Doc. No. BECO/ESR-1
SEPTEMBER 1984
REV. 1

Detailed Control Room Design Review

Executive Summary Report

Pilgrim Station

FIGURE 3-73.
ROD SELECTOR PUSHBUTTONS

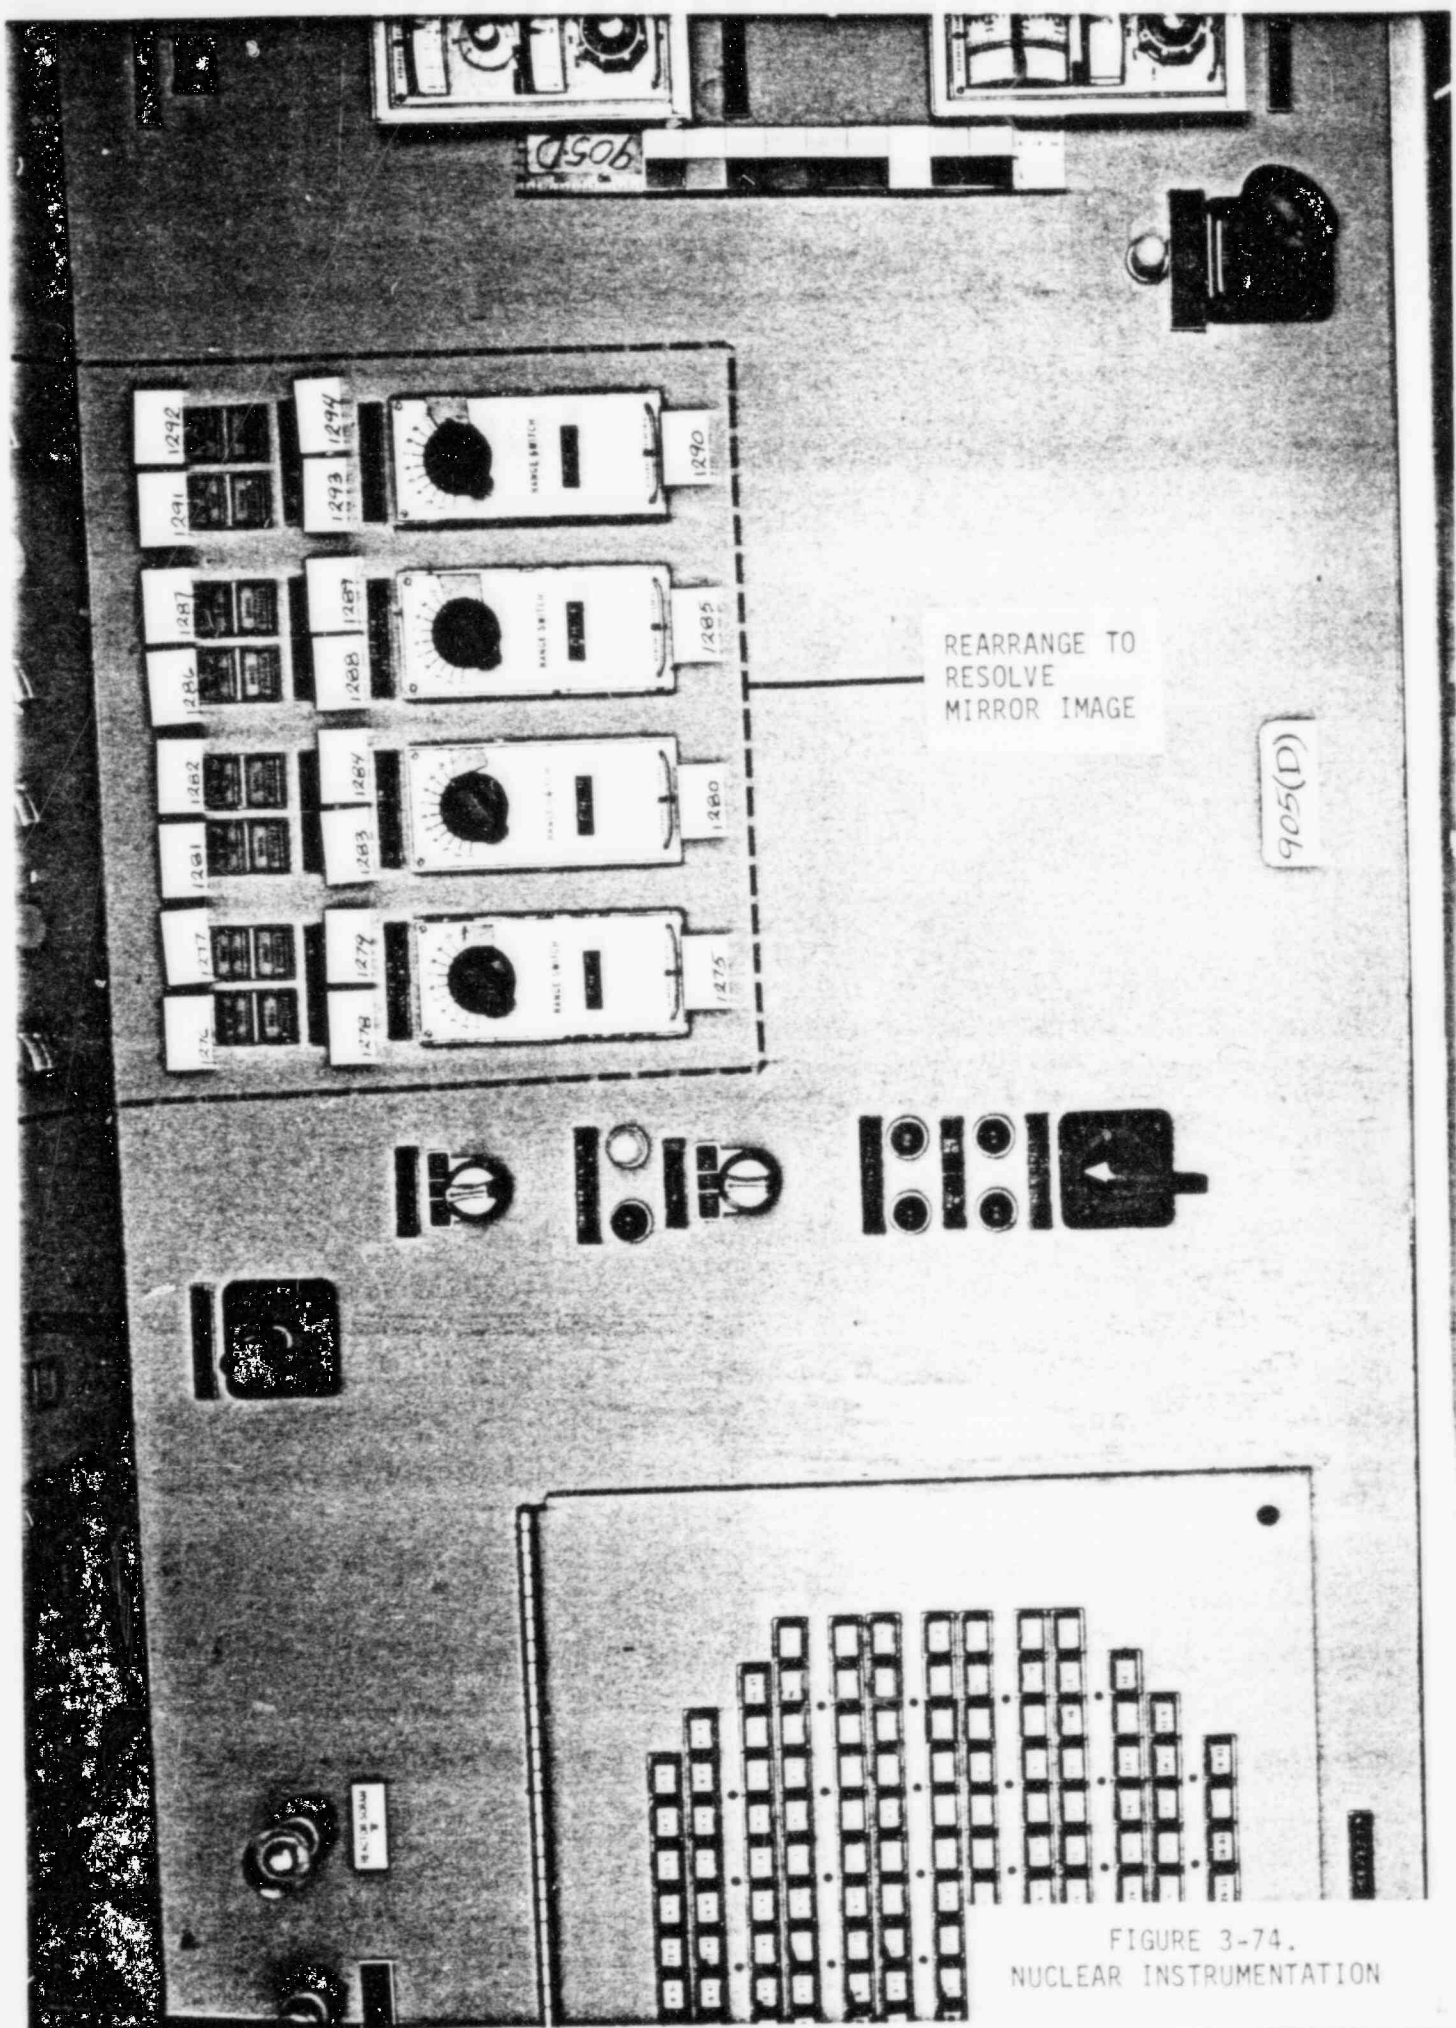
Figures 3-61, 62, and 63 show the rod control matrix lights and Figure 3-73 shows the rod selector push buttons associated with HEDs 8B094.5 and 4B027.5. The human factors problems of a maximum light string length will be overcome by demarcation; it will also be coordinated with demarcation on the rod selector push buttons. The barrier problem for the push buttons will be included in the final layout.

ENHANCE WITH
DEMARCATON
EVALUATE FOR
BARRIERS

FIGURE 3-74.
NUCLEAR INSTRUMENTATION

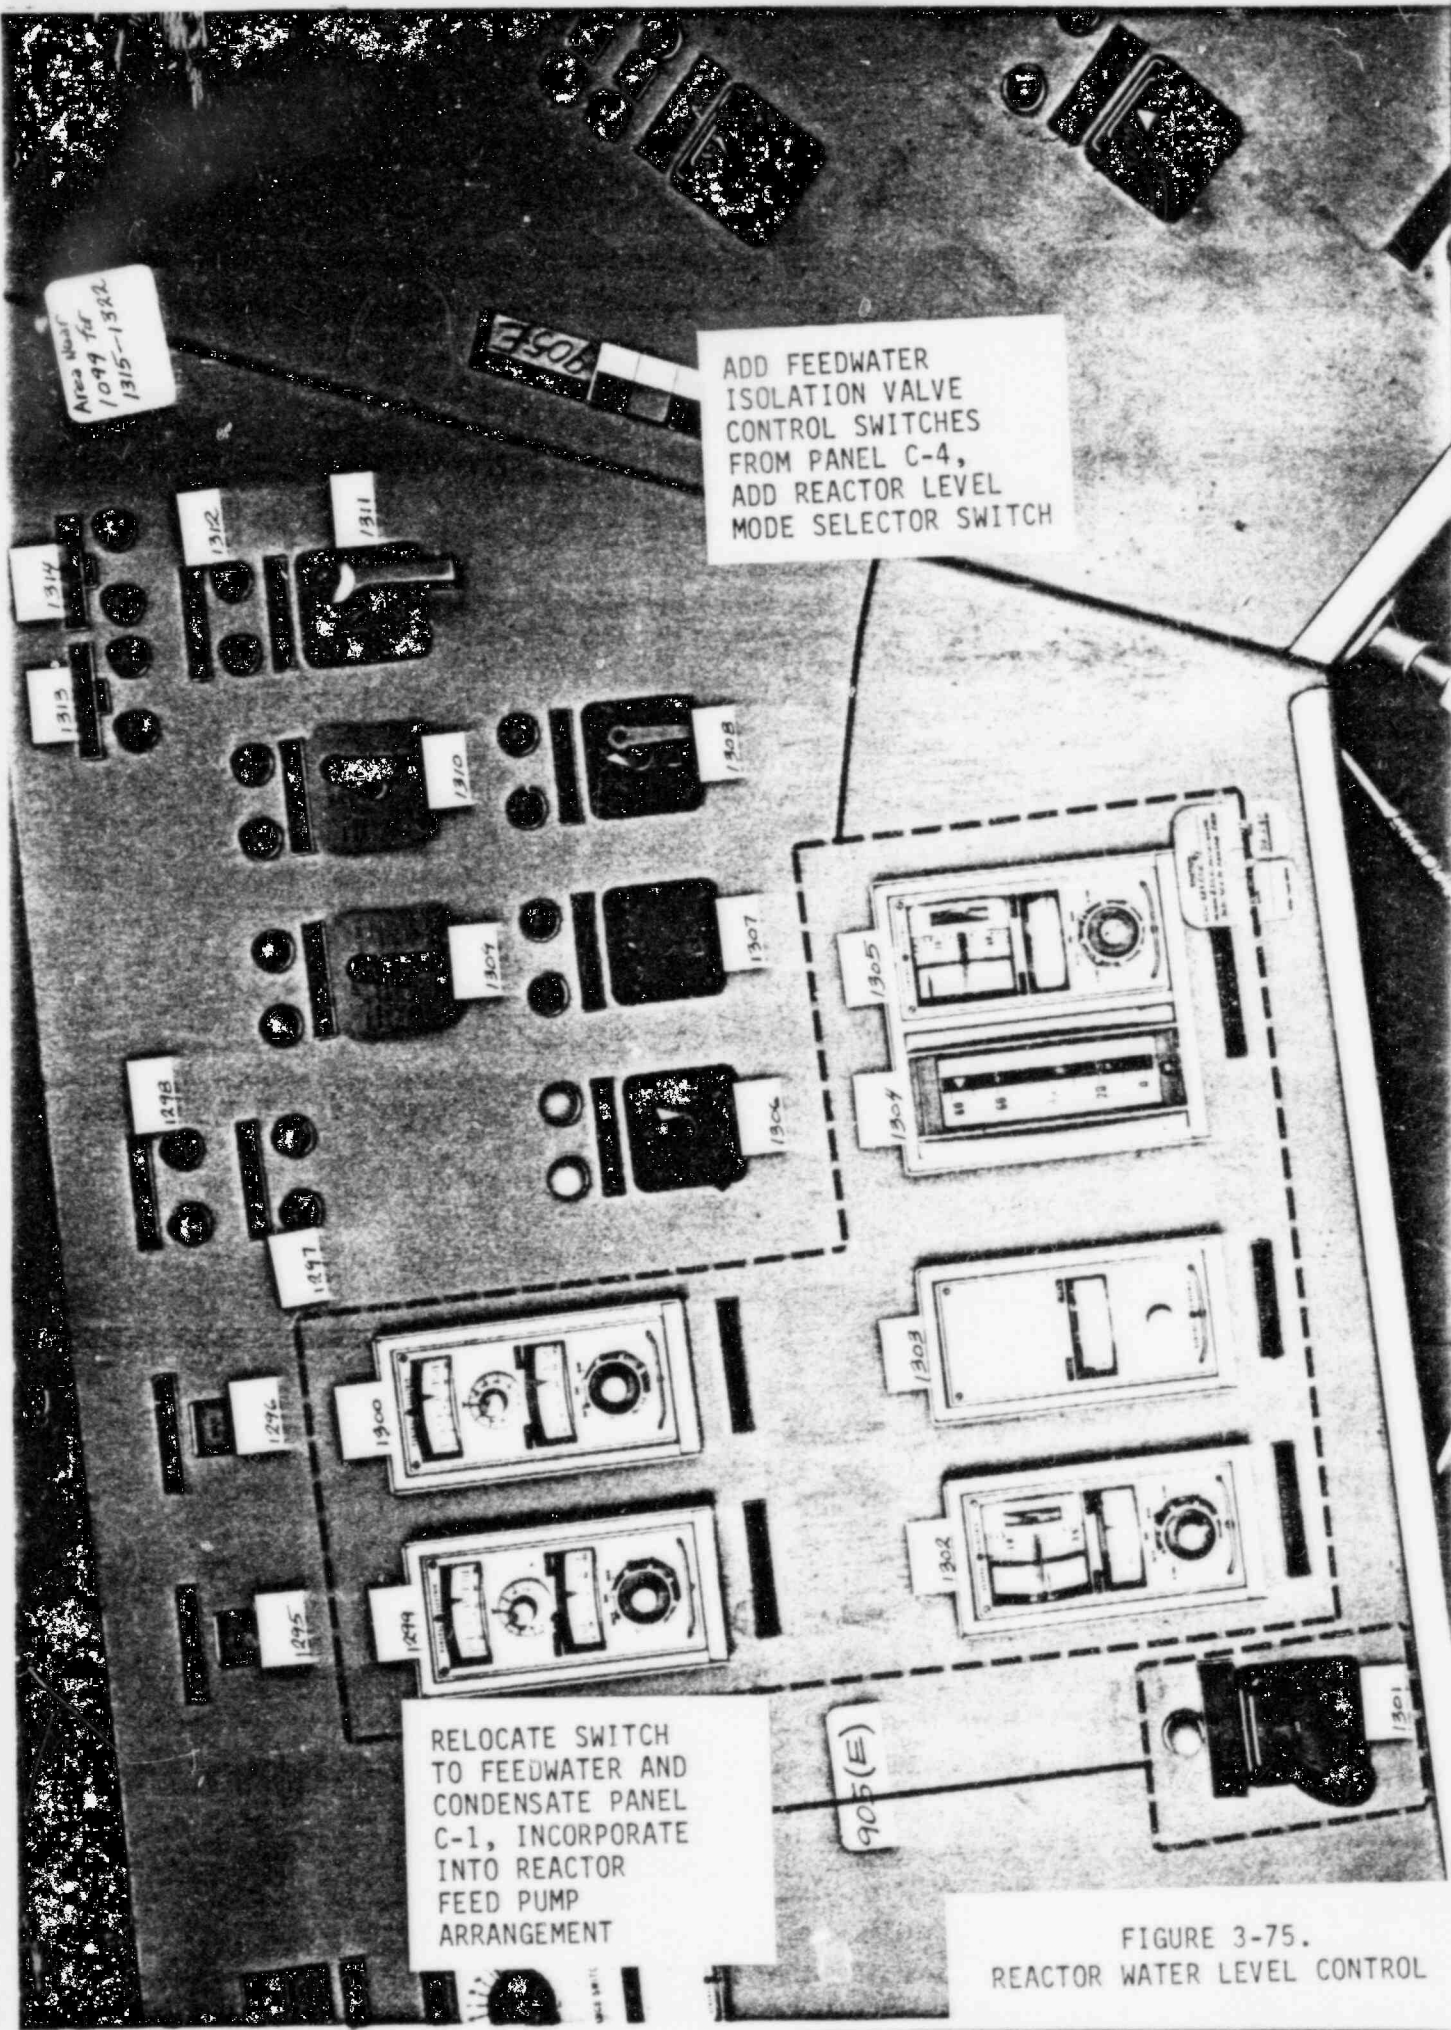
REARRANGE TO
RESOLVE
MIRROR IMAGE

ADD FEEDWATER ISOLATION VALVE CONTROL SWITCHES FROM PANEL C-4, ADD REACTOR LEVEL MODE SELECTOR SWITCH
